11" Pull Out App Option Divider App

STATUS
05
11" Pull Out App Option Divider App
546.31.800

RevNo	Project # or change Request #	Date	Signature	Checked
001	File updated	12.01.2011	NPG	RM

11" Pull Out Container Shelf	546.31.830
------------------------------	------------

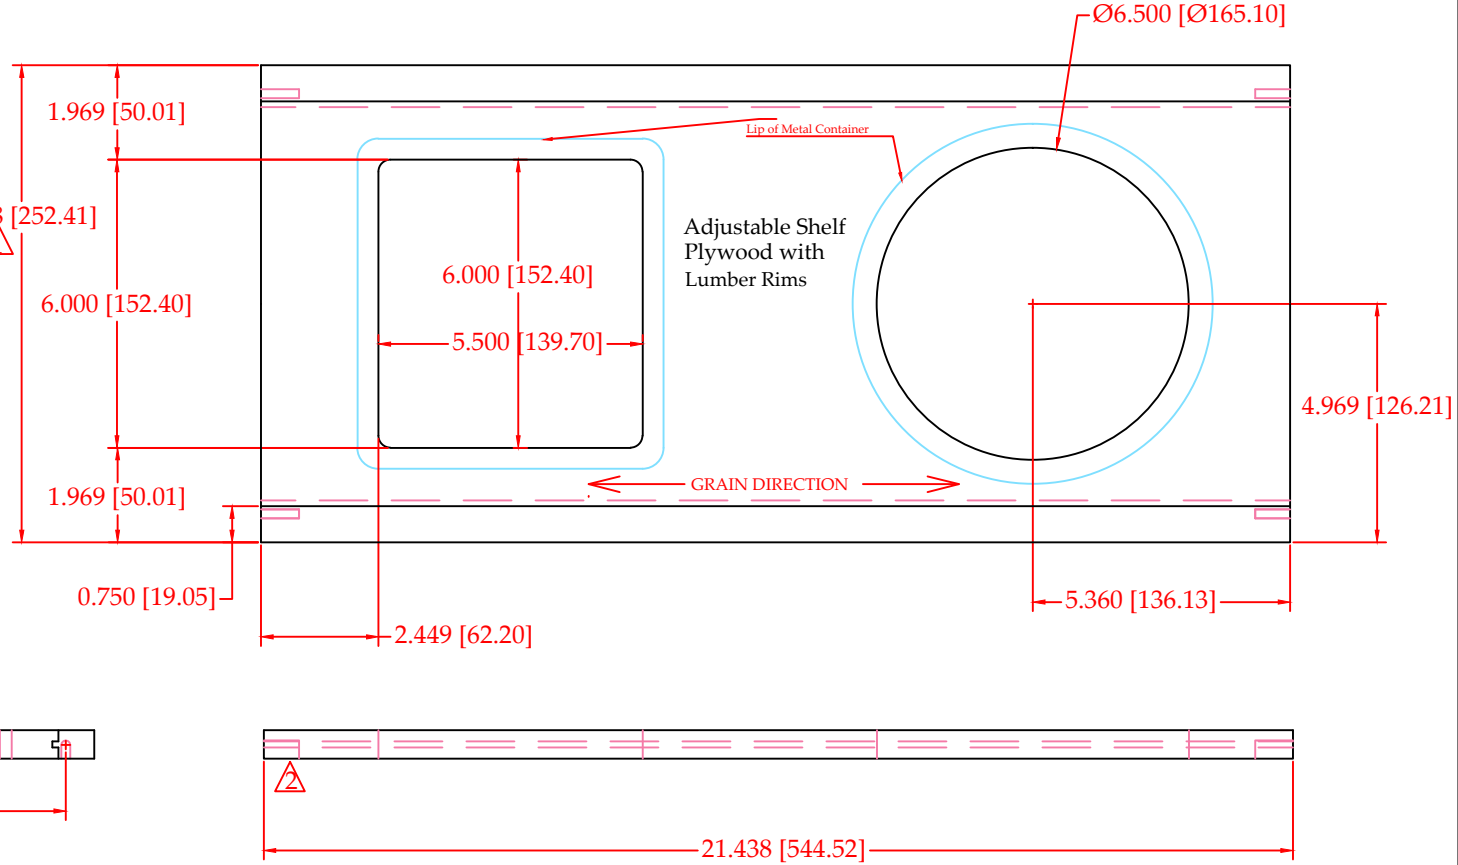
- ⚠ 10NOV11-Overall width from 11" to 9-15/16"
- ⚠ 10NOV11-Drilled Holes Replaced with Slots

DEMI CONTAINER SHELF Ap-11" Unit
(for Use With Vertical Divider Ap)

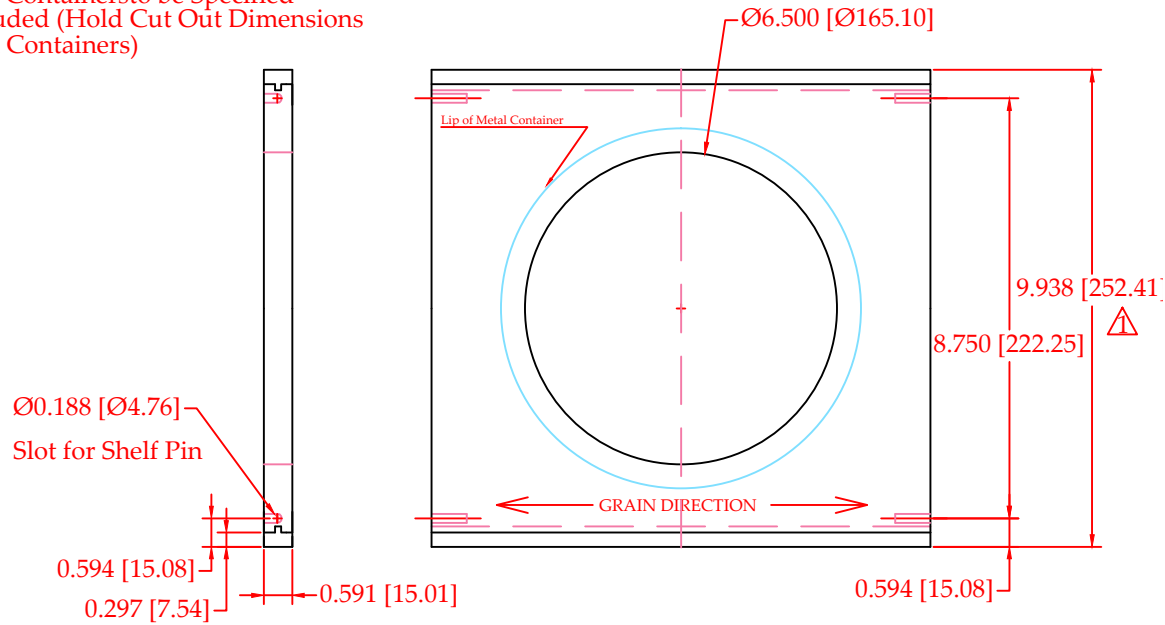
- ⚠ 11NOV11-Overall Width Decreased
- ⚠ 10NOV11-Drilled Holes Replaced with Slots

CUTLERY TRAY Ap-11" Unit

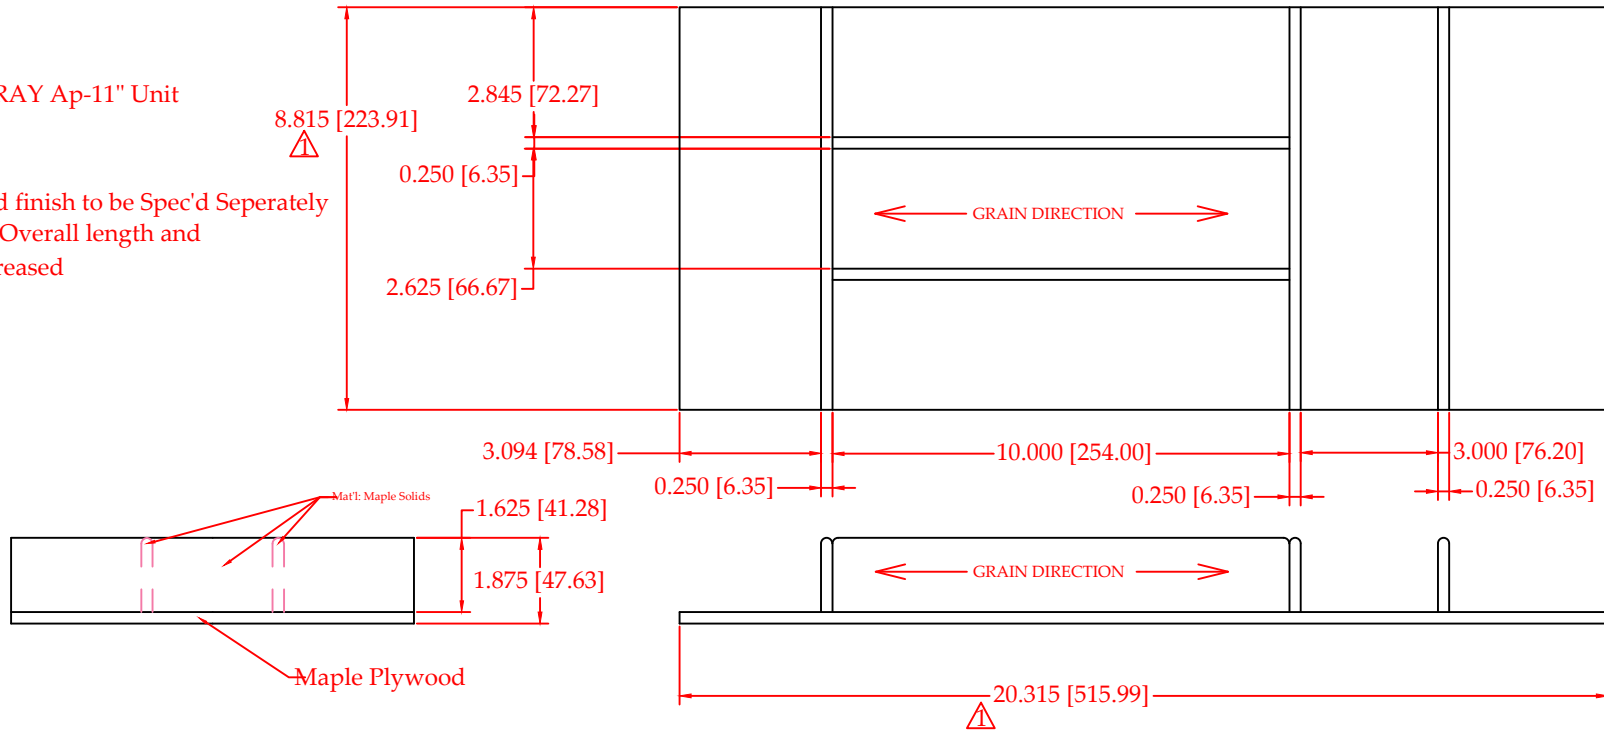
Materials and finish to be Spec'd Separately
 ⚠ 11NOV11-Overall length and width increased

DEMI CUTLERY TRAY Ap-11" Unit
(for Use With Vertical Divider Ap)

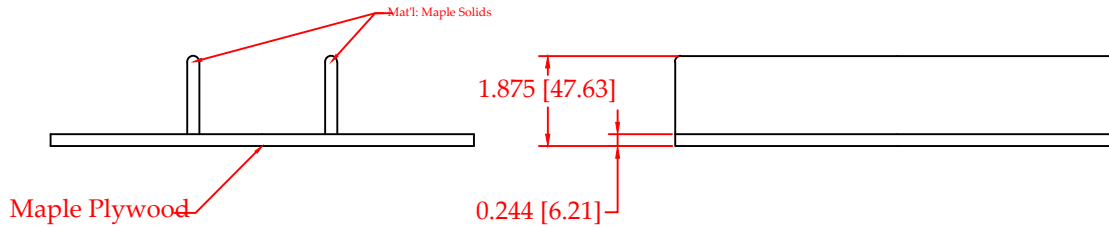
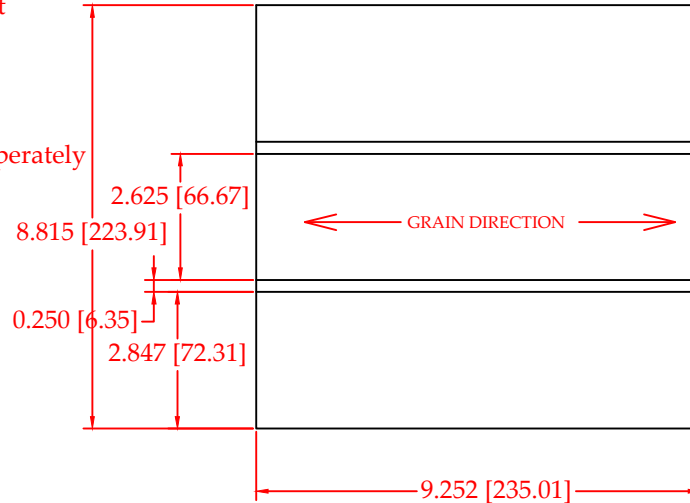
Materials and finish to be Spec'd Separately
 ▲ 11NOV11-Overall length and width increased

CUTTING BOARD Ap-11" Unit

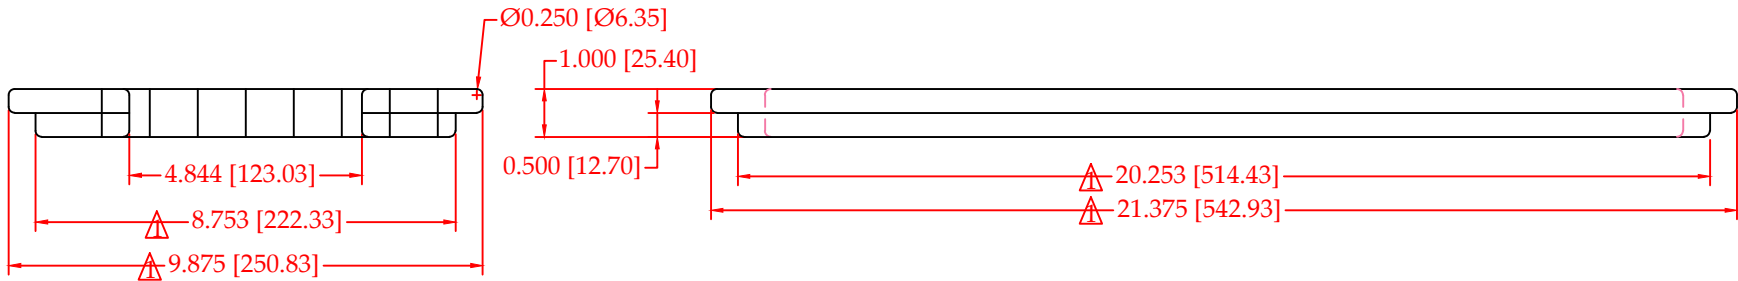
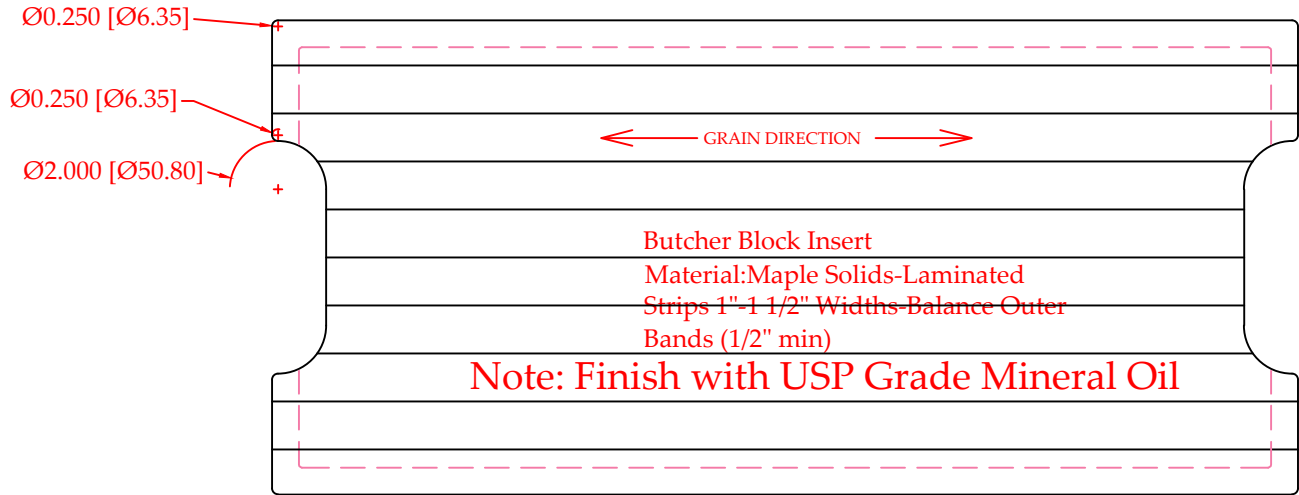
Materials and finish to be Spec'd Separately
 ⚠ 11NOV11-Overall length and width increased by 1/8"

DEMI CUTTING BOARD Ap-11"Unit
(for Use With Vertical Divider Ap)

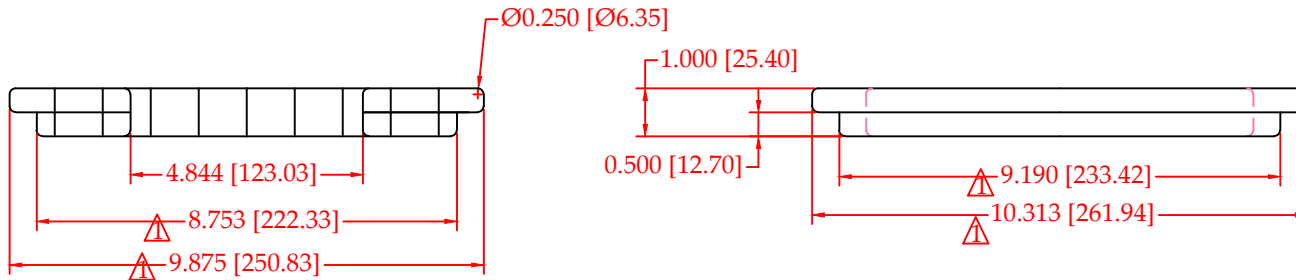
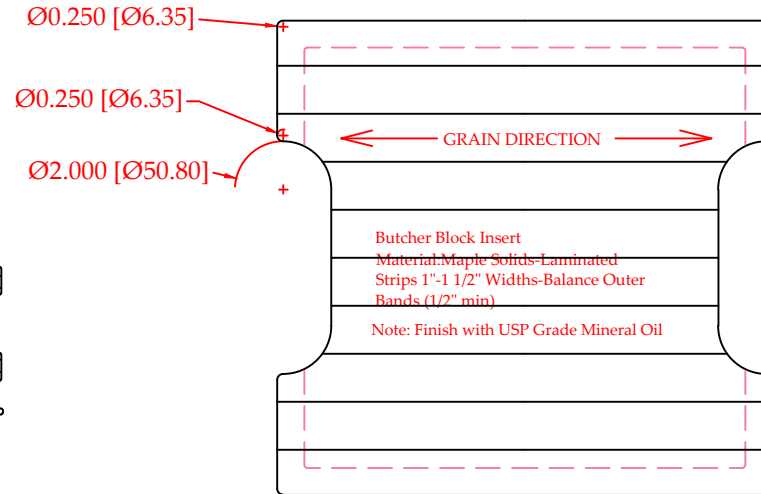
Materials and finish to be Spec'd Separately
 ⚠ 10NOV11-Length and Width Increased

DEMI-DROP-IN TRAY Ap-11"Unit
(for Use With Vertical Divider Ap)

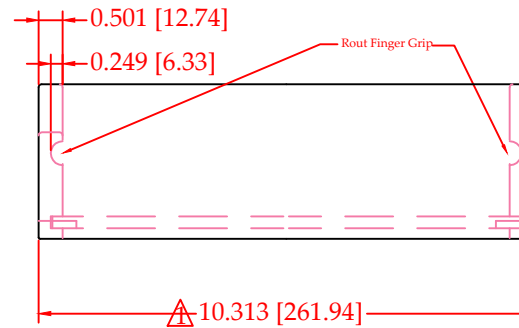
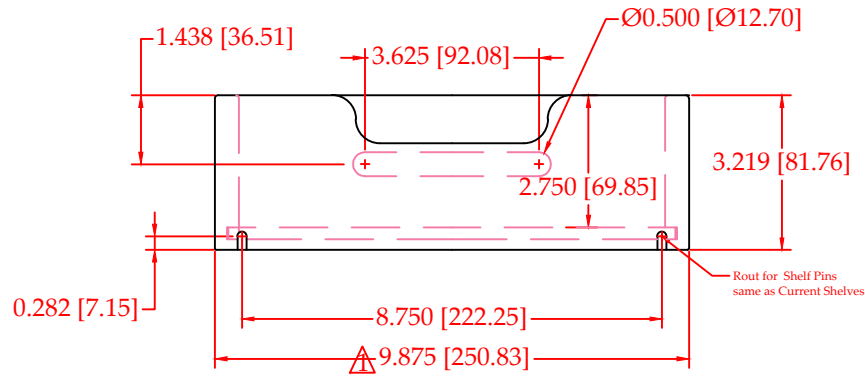
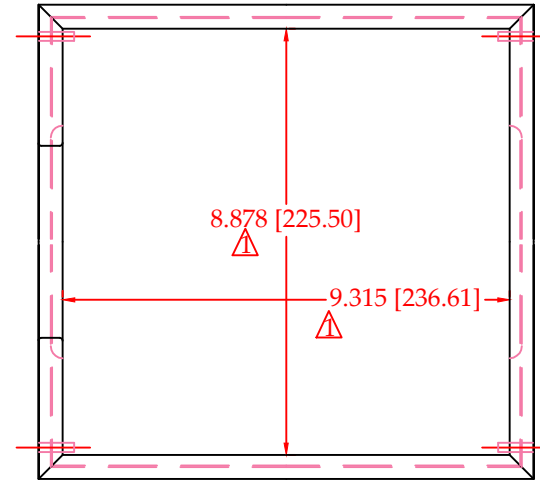
Materials and finish to be Spec'd Separately
 ⚠ 10NOV11-Length and Width Increased

STATUS
05
11" Pull Out Drop in Tray
546.31.861

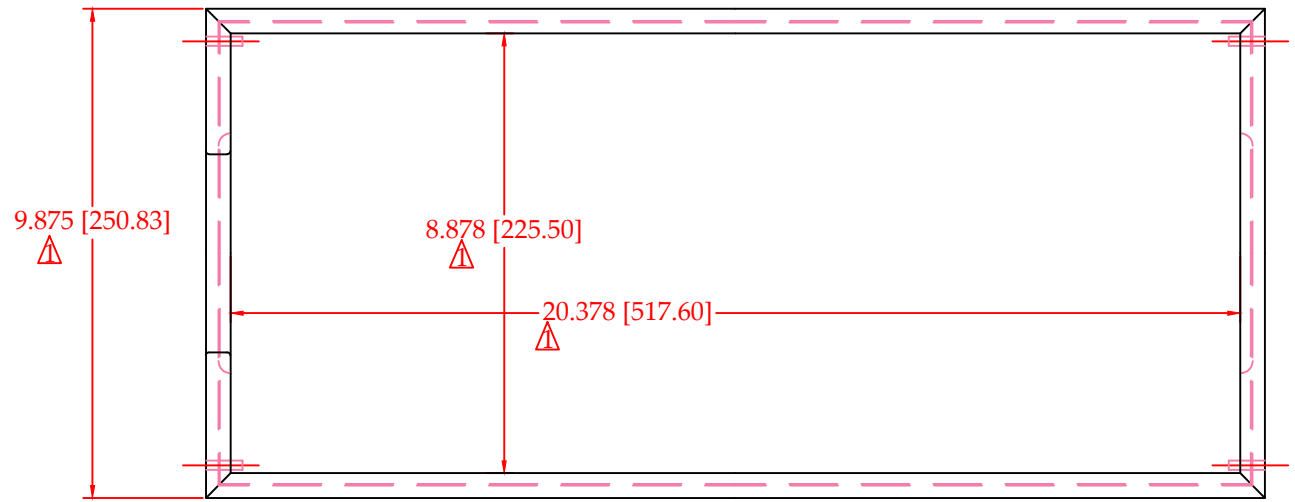
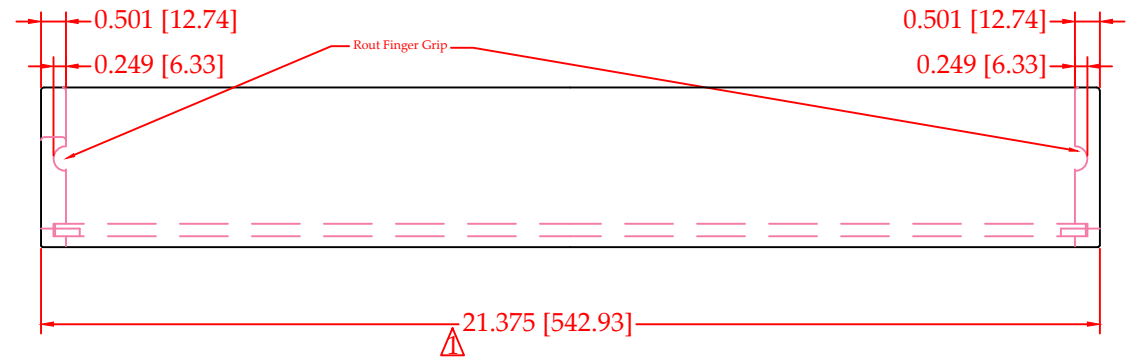
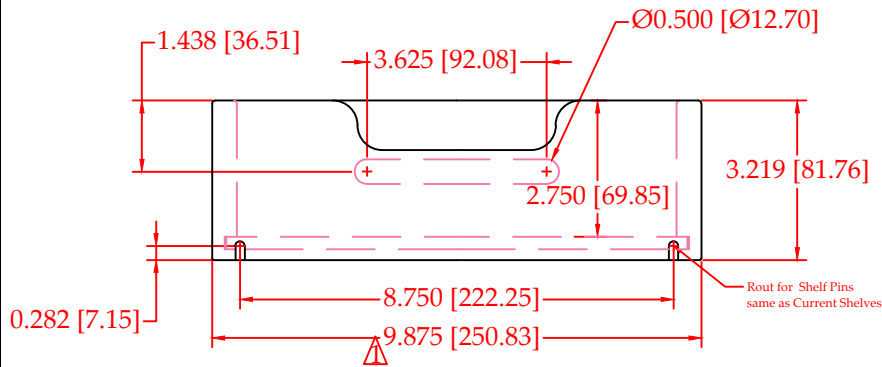
Drop-in App Tray
 Material-Solid lumber sides
 Plywood Bottom
 Materials and finish to be Spec'd Separately
 ⚠ 11NOV11-Overall length and width increased by 1/8"

**DEMI SPICE TRAY Ap-11"Unit
(for Use With Vertical Divider Ap)**

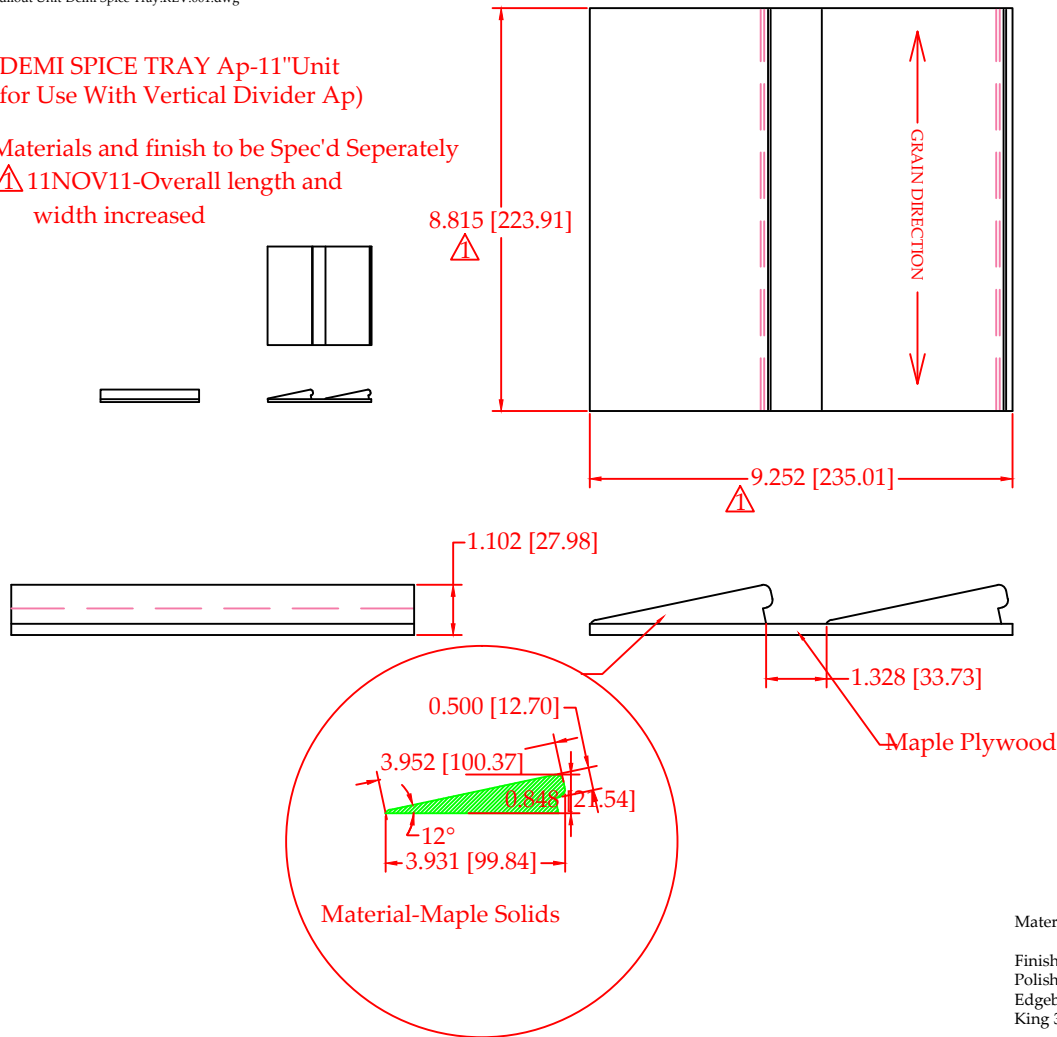
⚠ 11NOV11-Overall length and width increased

ROLL MANAGEMENT Ap-11" Unit

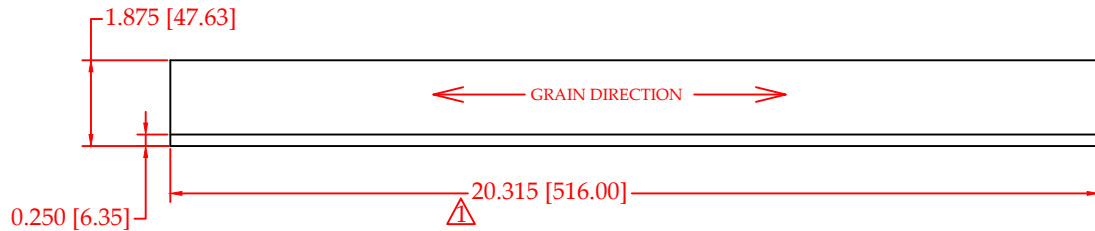
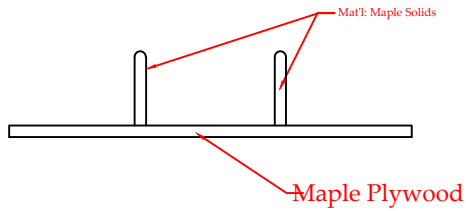
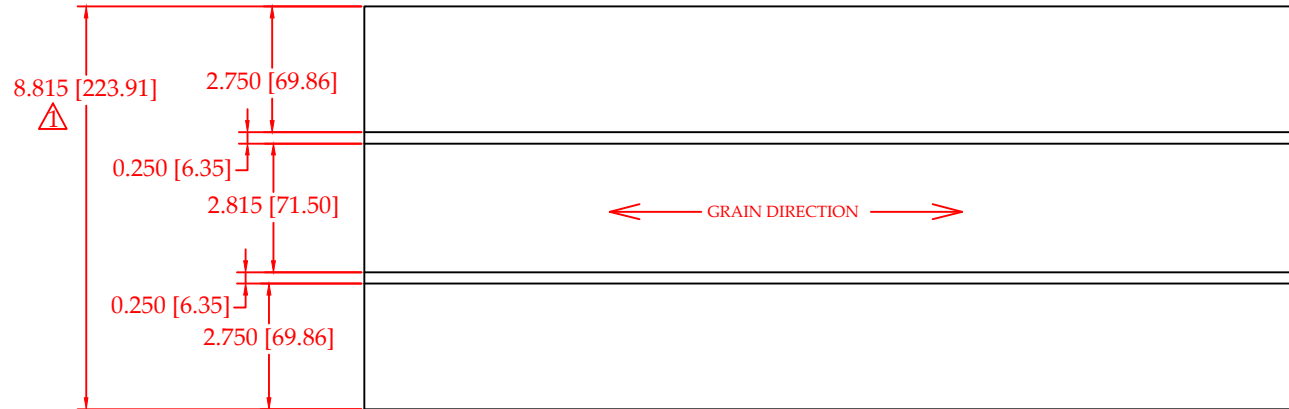
Materials and finish to be Spec'd Separately
 ⚠ 11NOV11-Overall length and width increased

SPICE TRAY Ap-11" unit

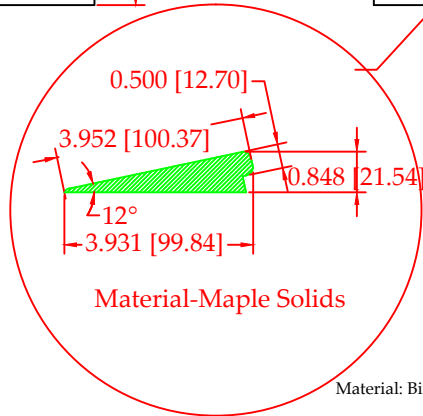
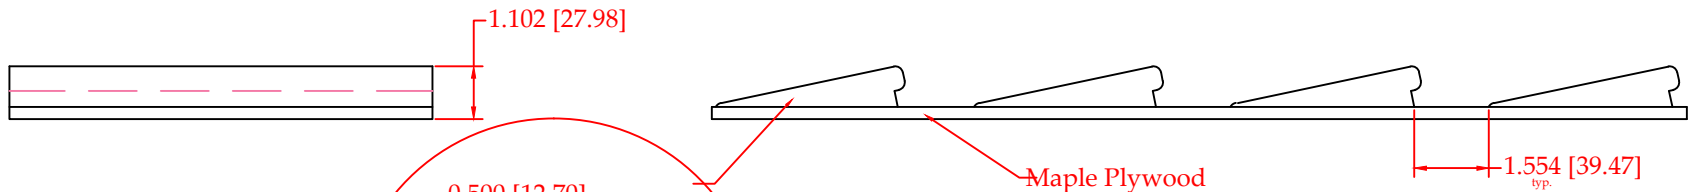
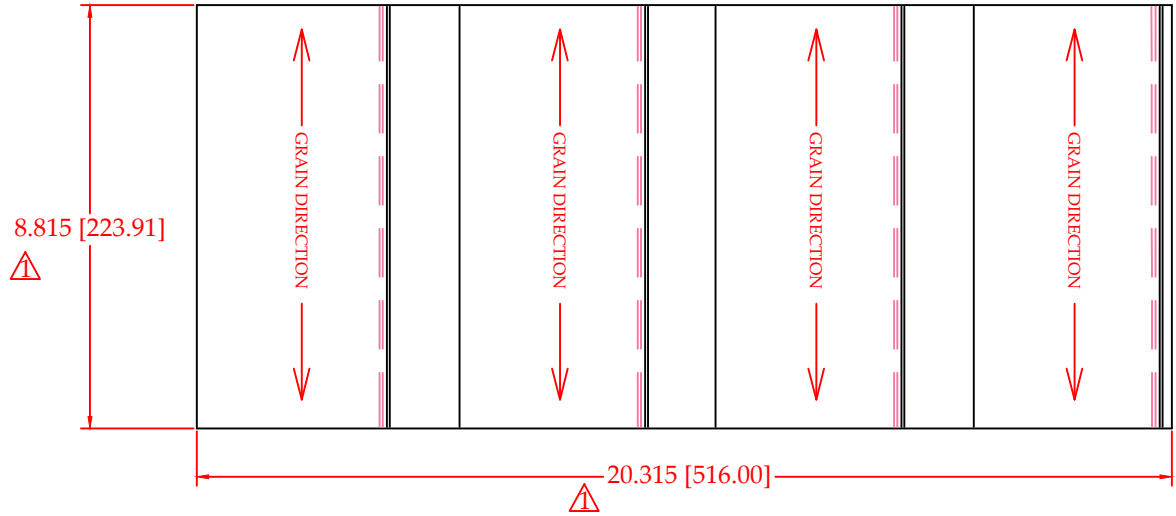
⚠ 11NOV11-Overall length and width increased
